ABERDEEN SCHOOL DISTRICT #5
Aberdeen School District Capital Projects 2026

410 North G Street
Aberdeen, WA 98520

INDEX TO ADDENDUM 1:

FS-1

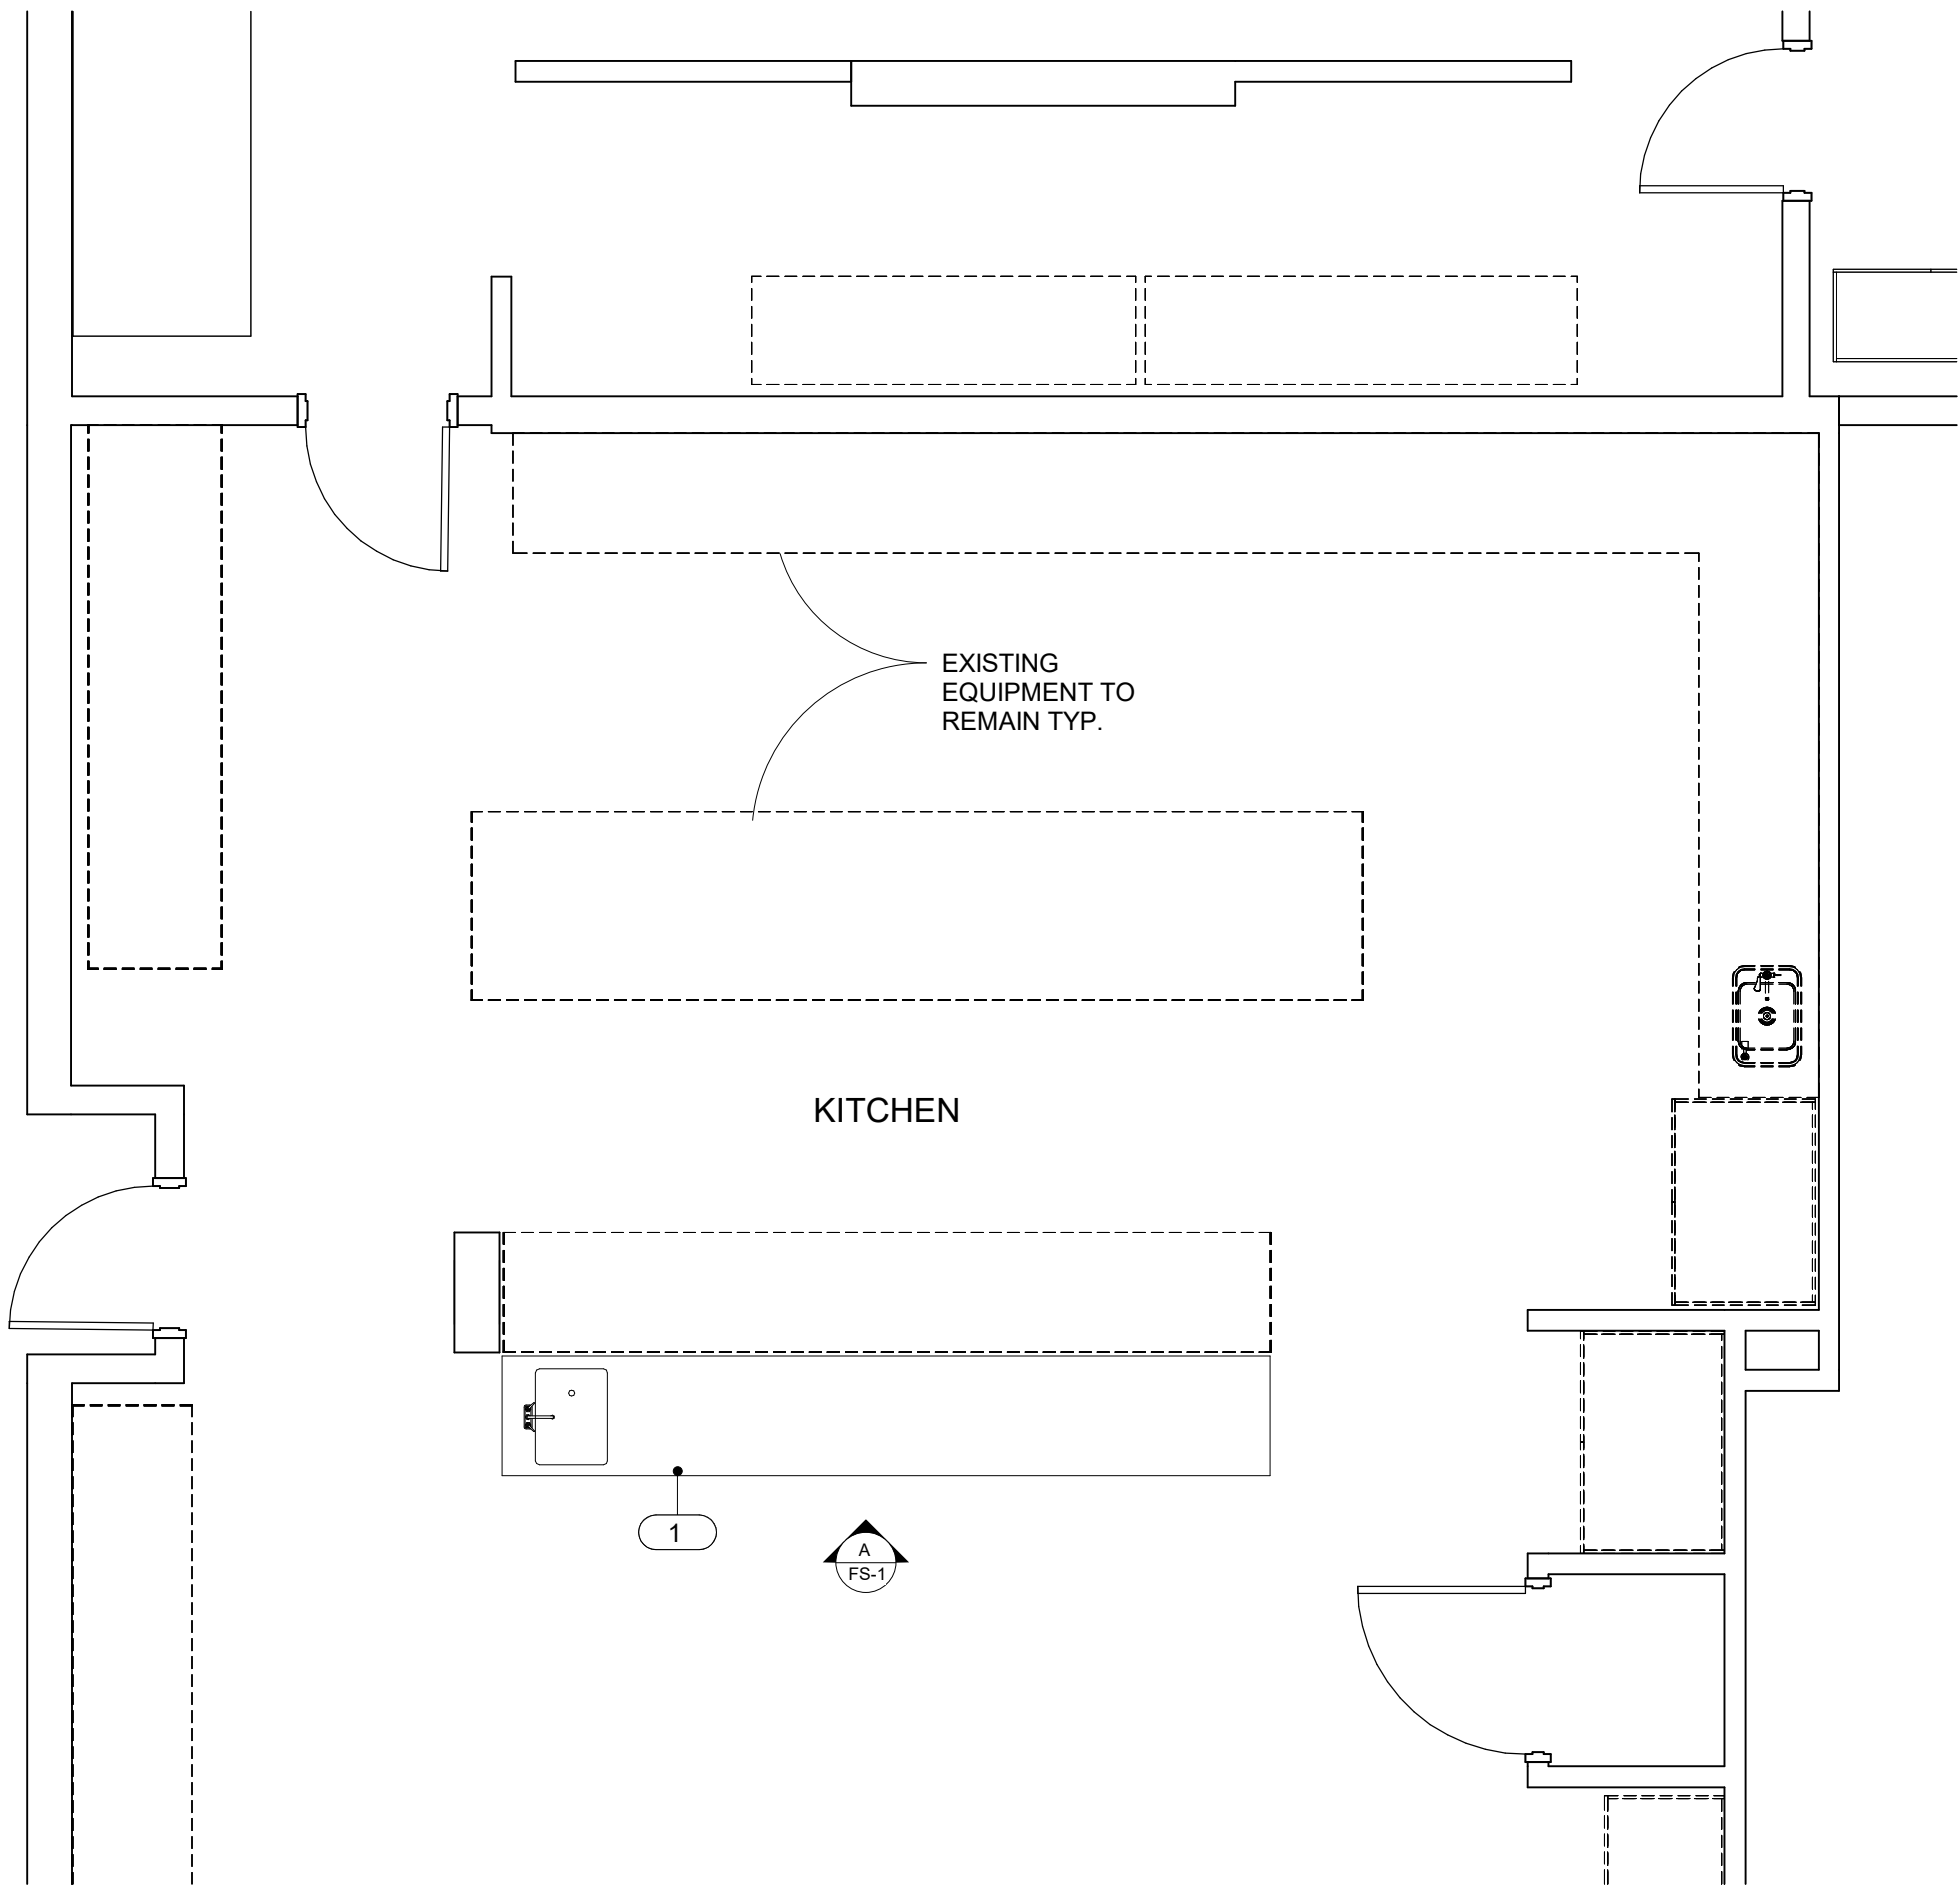
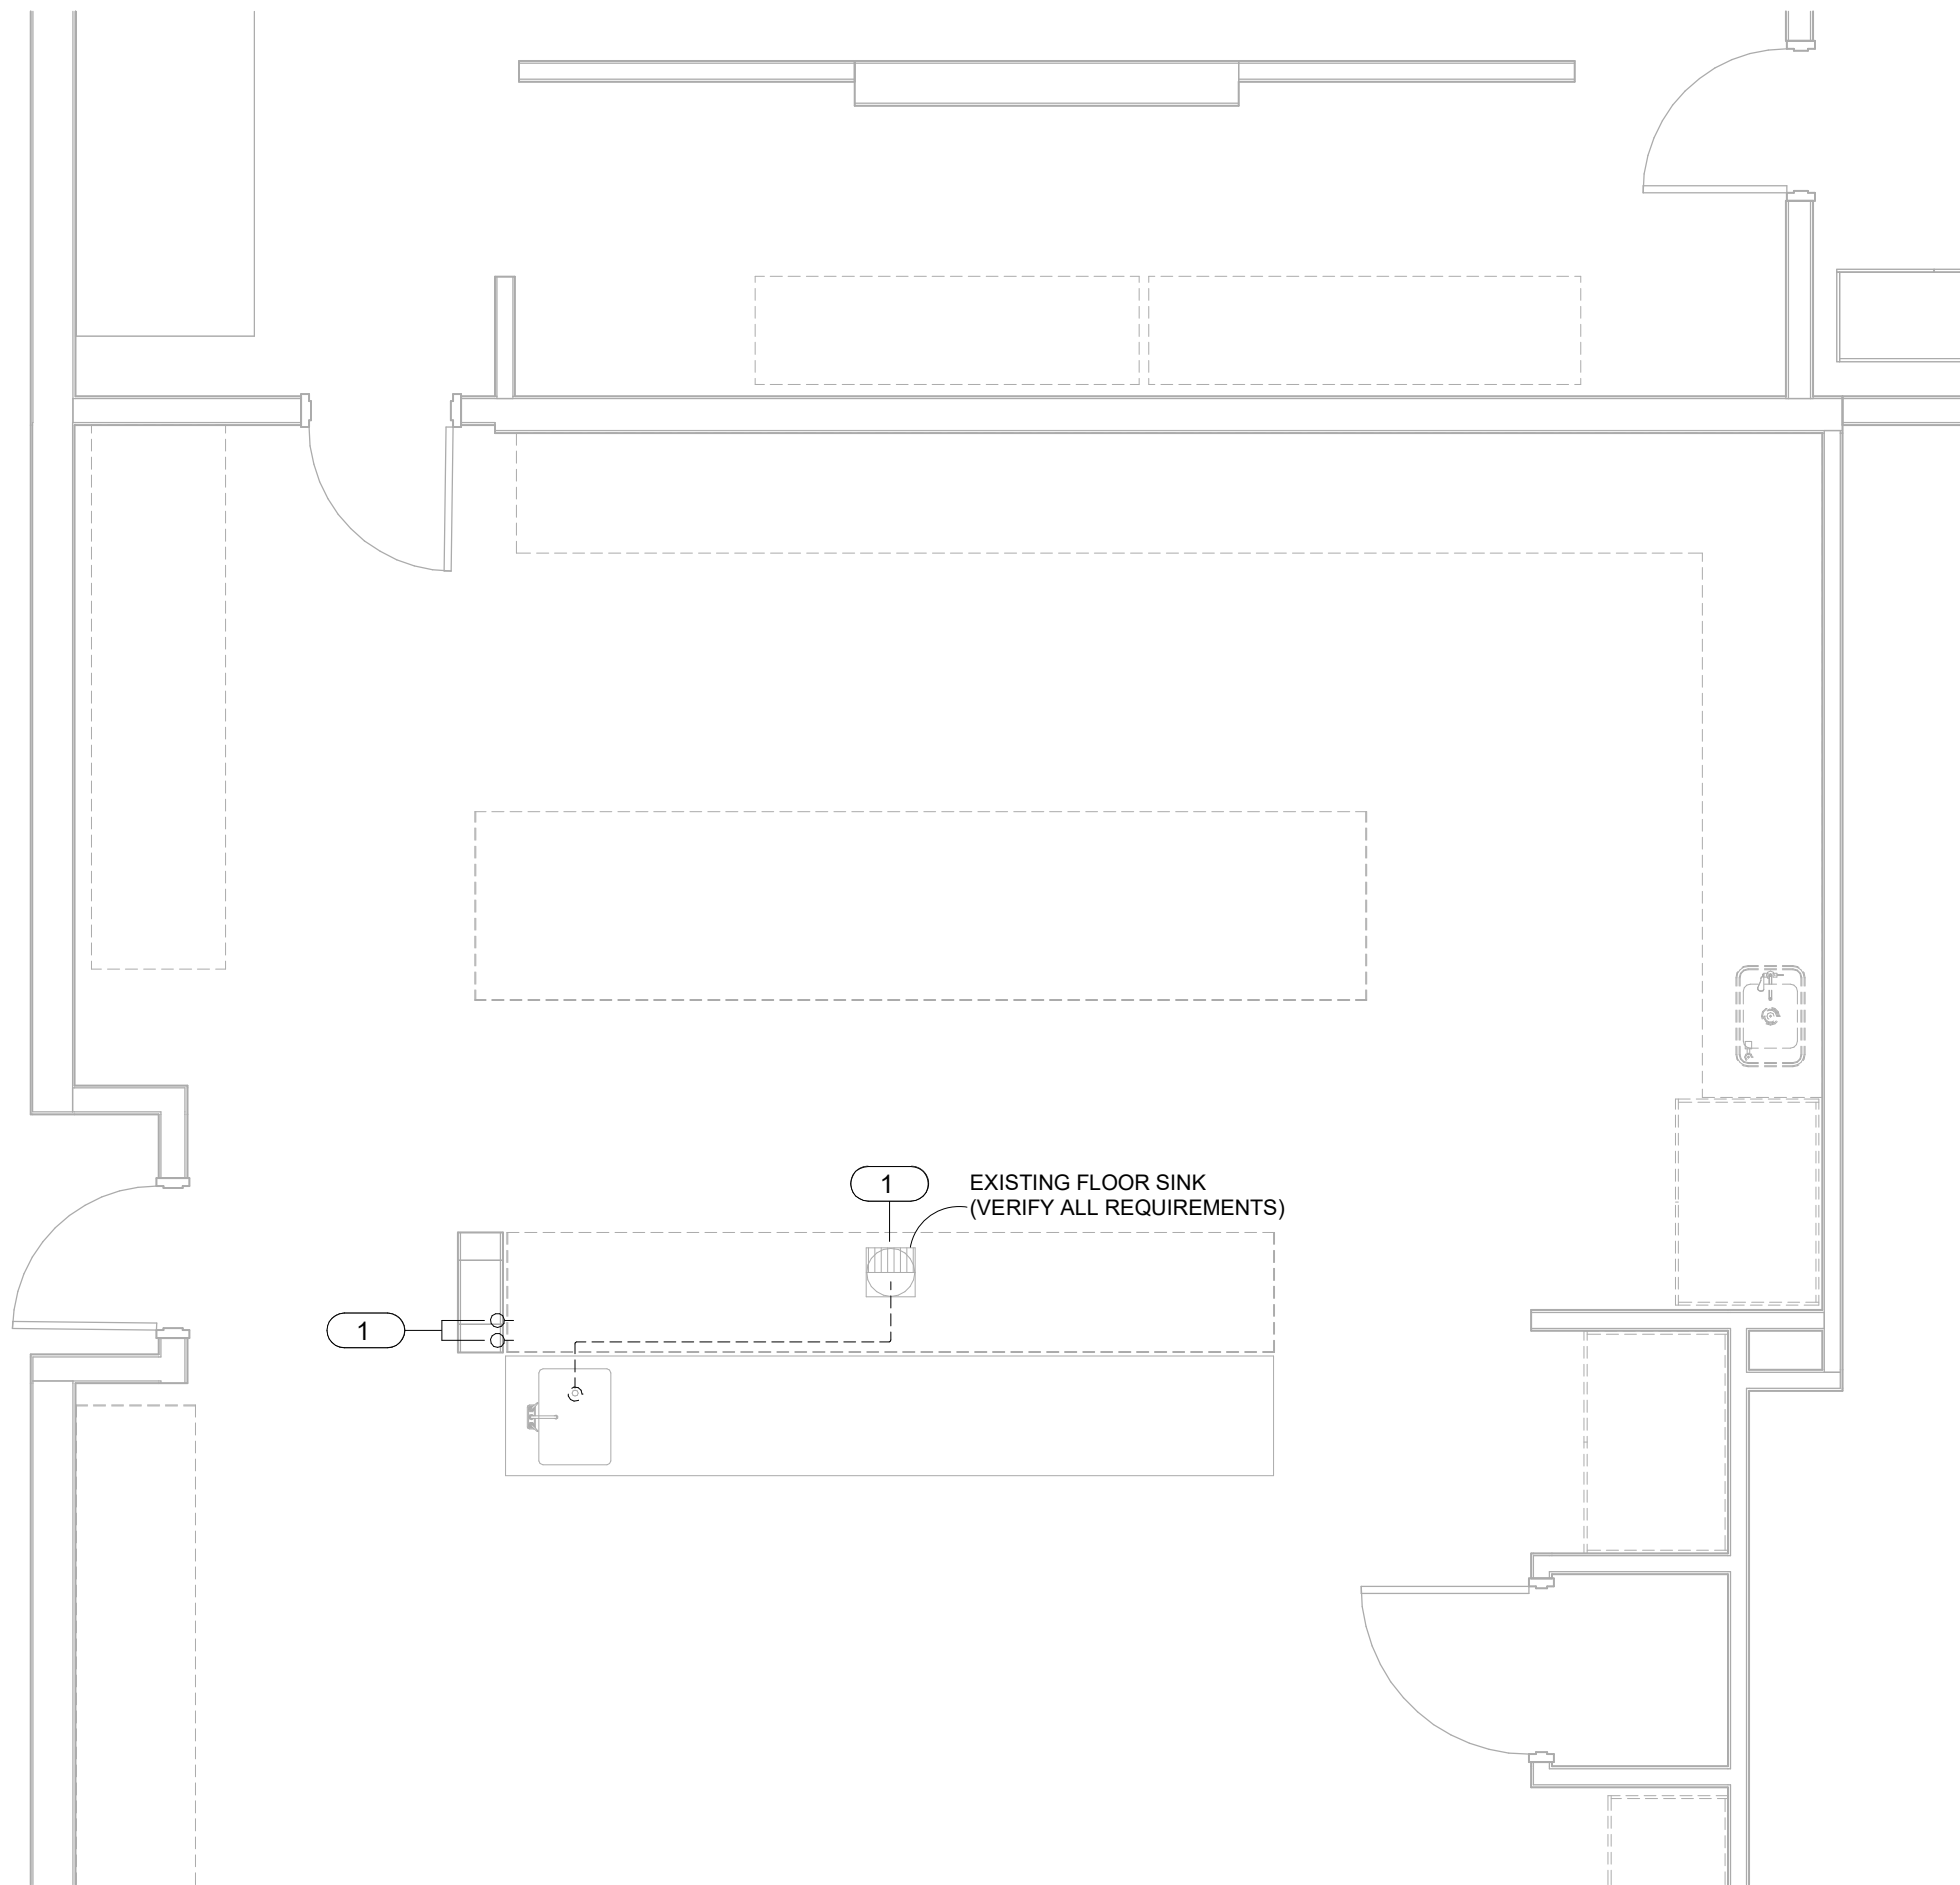
Answer: Refer to revised scope of work in specifications section 011000 included in Addendum 1 and revised drawings and specifications.
 - 5. **Question:** At Culinary Classroom, Is an in-direct drain required for the new sink? Is this a food processing sink?

Answer: Yes, in-direct will be required, see sheet FS-1.
 - 6. **Question:** At guardrail work, How is the fastener anchoring at the bottom holding?

9. **REPLACE** sheet **A72.10** in its entirety.
- B. Food Service Drawings
1. **REPLACE** sheet **FS-1 EQUIPMENT PLAN** in its entirety.
- C. Mechanical Drawings
